April 21, 2020

RE: WAP-20-01/WRG-20-01/MIS-20-01/LLA-20-01

Please accept this letter and the accompanying materials as our complete response to the City's February 5, 2020 determination that our application was incomplete (see Attachment J). We believe the materials provided herein fully respond to the incompleteness items outlined in the City's letter and provide the necessary basis to deem the application complete. We look forward to continuing to work with City staff on any design and associated issues, as necessary, during the review and approval process.

FOUNDATION PLAN
 SCALE: 1/4" = 1'-0"

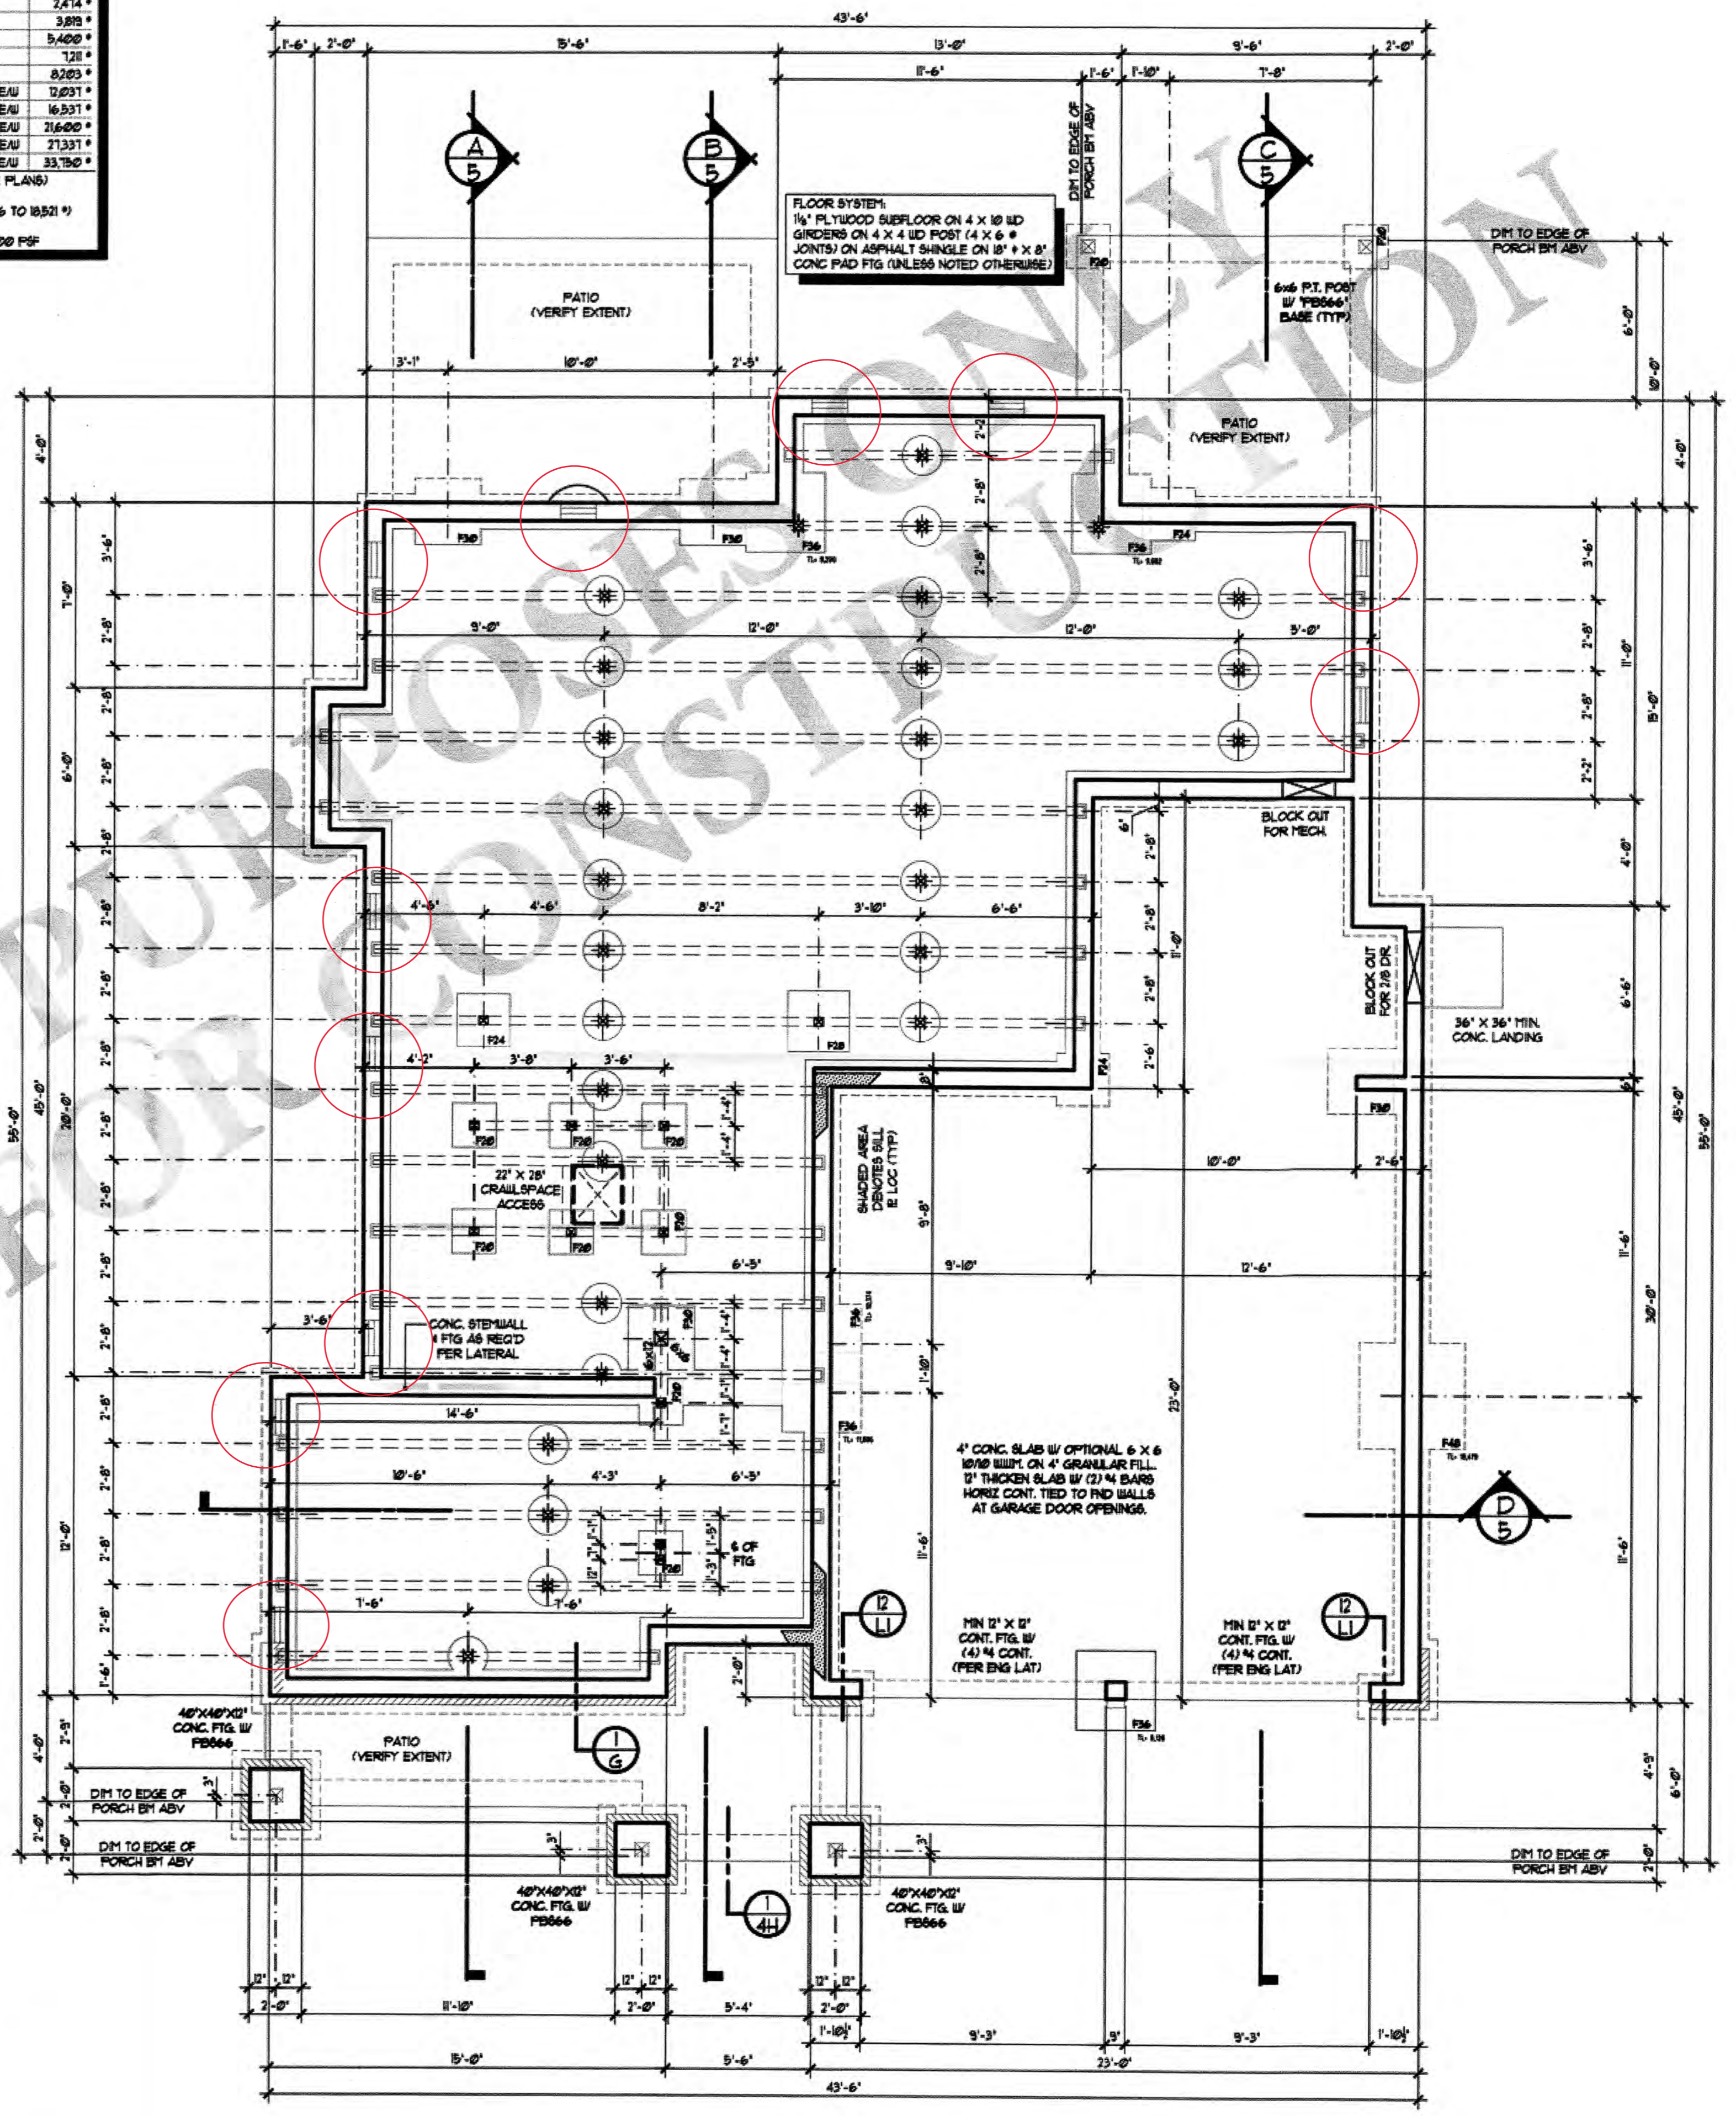
13. Provide foundation plans certified by a professional engineer of no increase in base flood elevation (including impact from the deck).

Response: Attachment E is a Preliminary/Conceptual Foundation Plan, prepared by Alan Mascord Design Associates and is intended to respond to planning related building information that is necessary for the requested land use permits. A new foundation plan will be provided to the City with the forthcoming Building Permit application and will include more specific detail with regard to foundation and home design. Such revised building plans will conform to all applicable criteria here.

REVISED SITE PLAN OVERVIEW	FIGURE
TAX LOTS 800 & 802 SITE ASSESSMENT REPORT	7
AKS ENGINEERING & FORESTRY, LLC 12965 SW HERMAN RD, STE 100 TUALATIN, OR 97062 503.563.6151 WWW.AKS-ENG.COM	DRWN: JRI CHKD: SAR AKS JOB: 5926

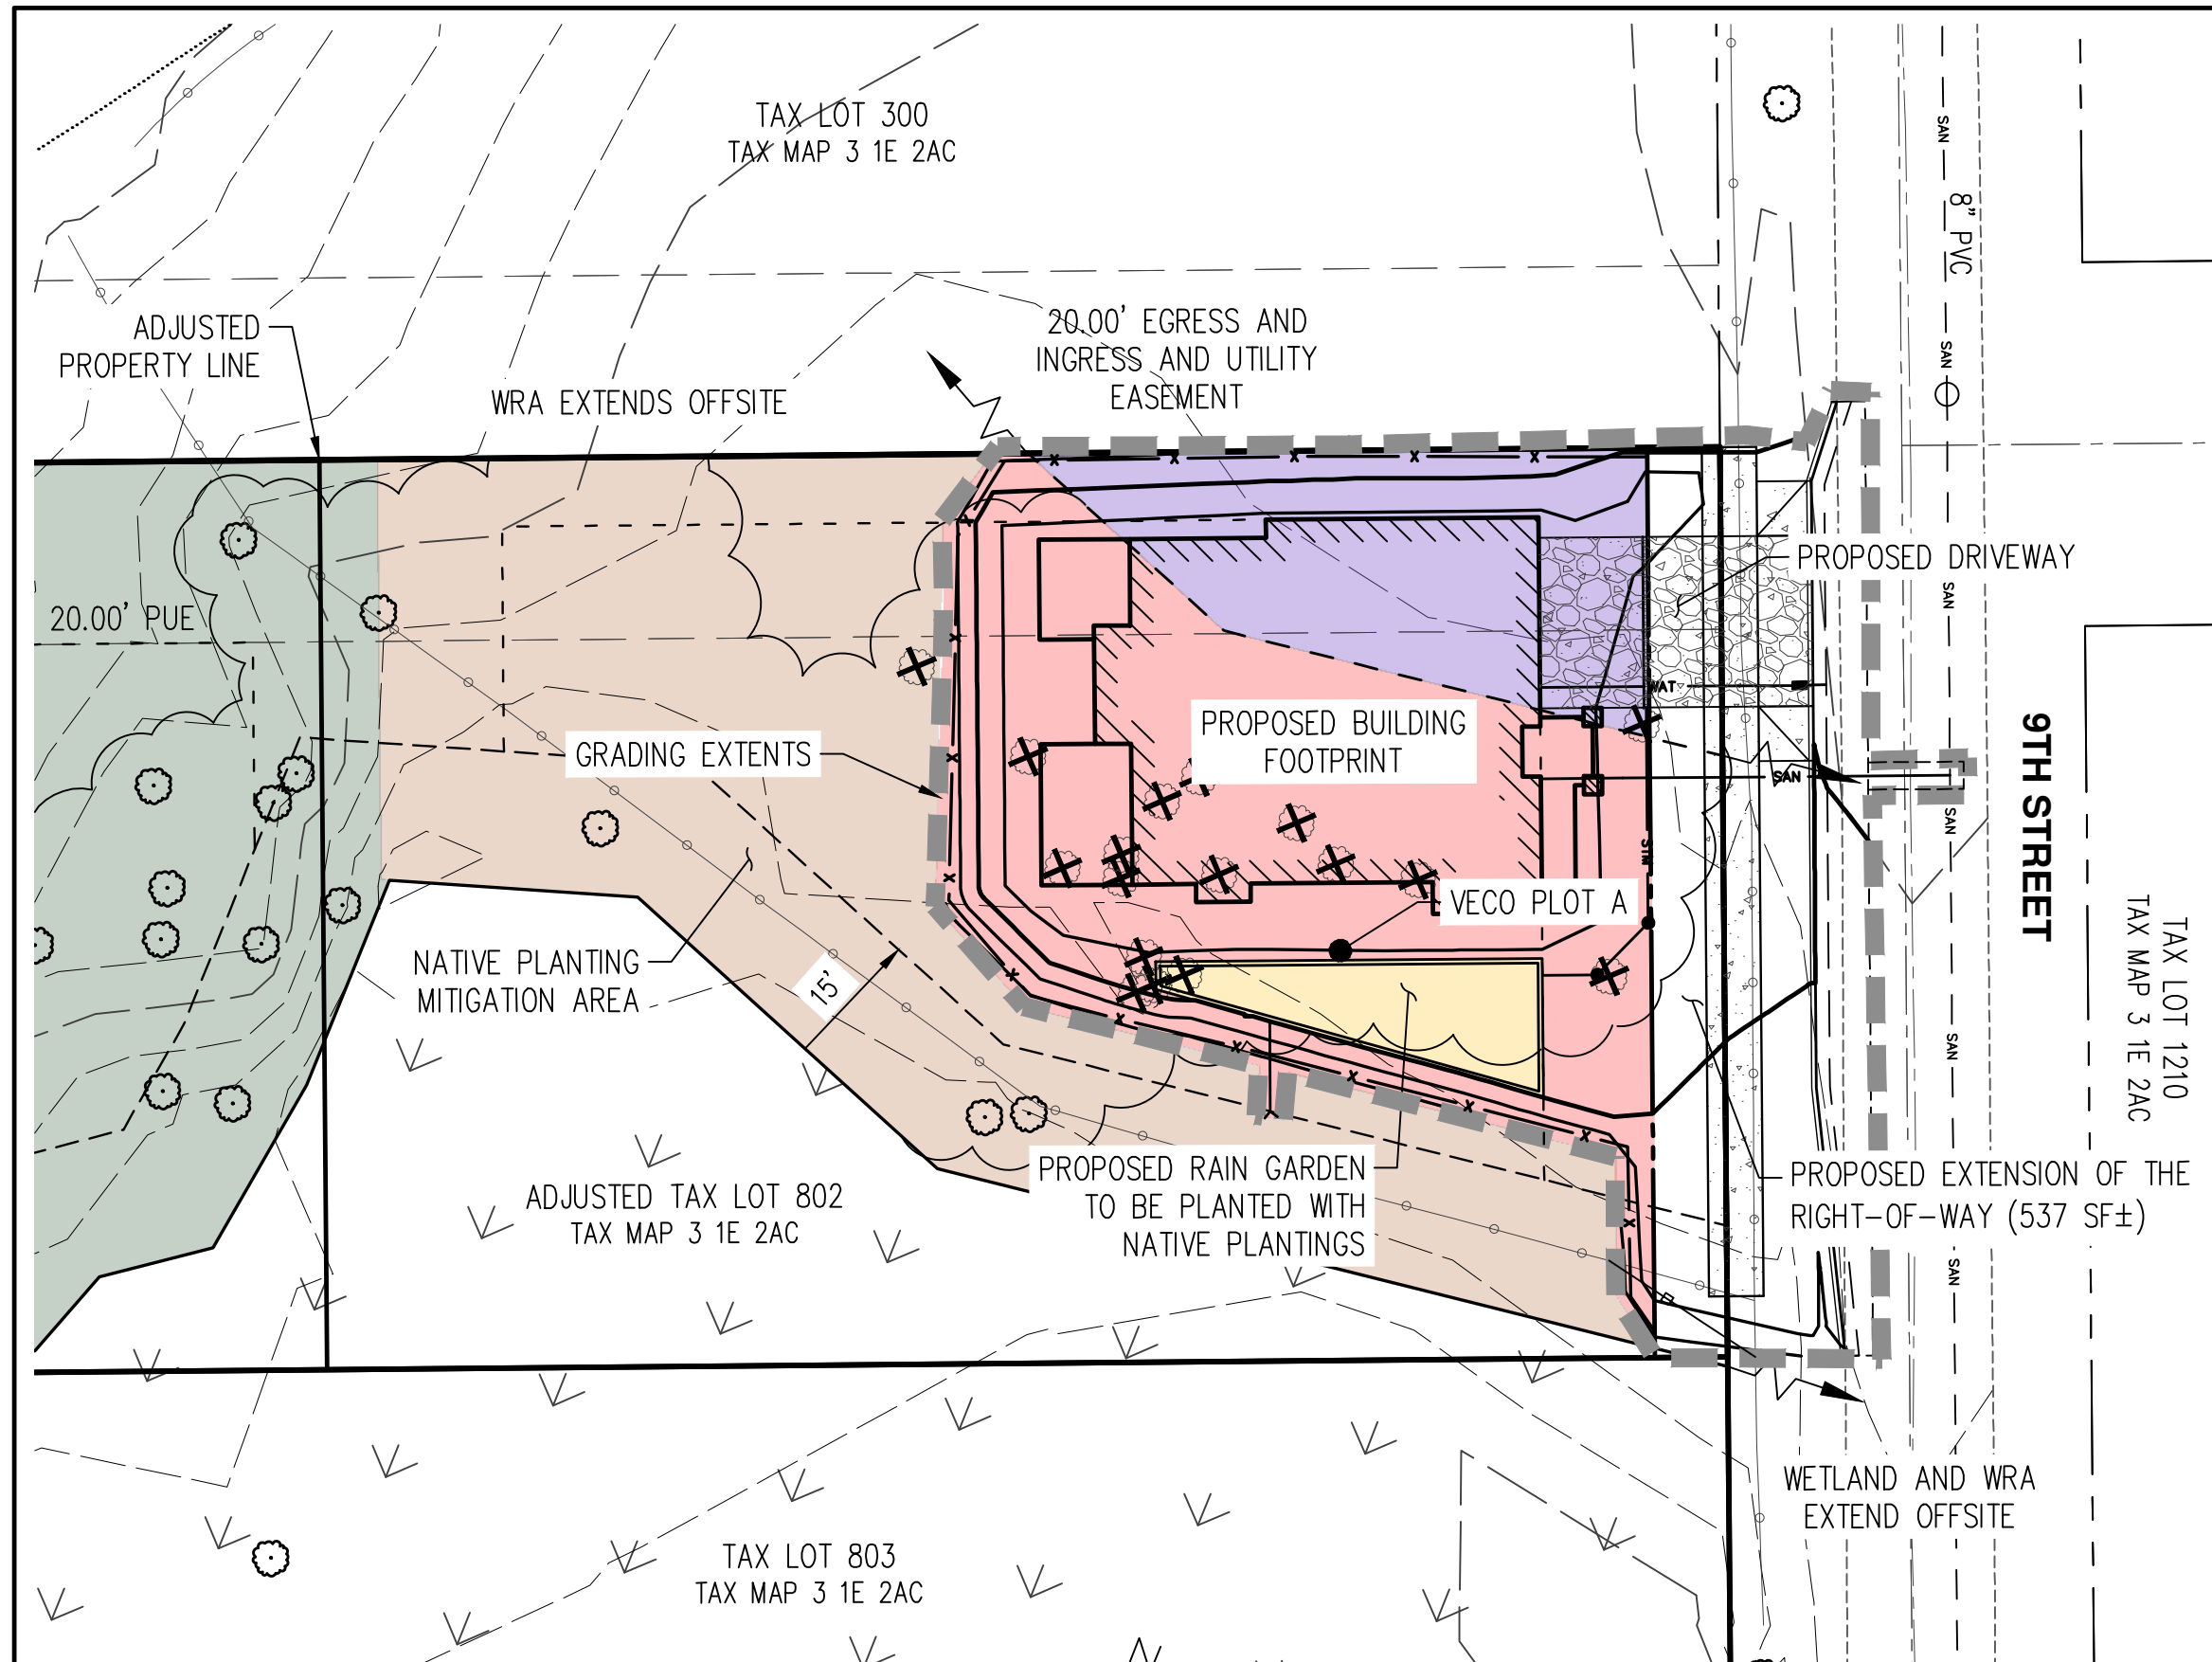
8. CDC Chapter 28.090.C(2) – Site Plan with HCA Boundaries. Please provide a site plan that includes the existing HCA boundary shown by low, moderate, and high.

Response: The Natural Resources Site Assessment Report provided to the City in the January 7, 2020 submittal, included an HCA Map as Figure 6 which shows the boundaries of the HCA. Attached as Attachment G, Figures 7 and 7A include a revised HCA map which includes the HCA Boundary by low, moderate, and/or high.
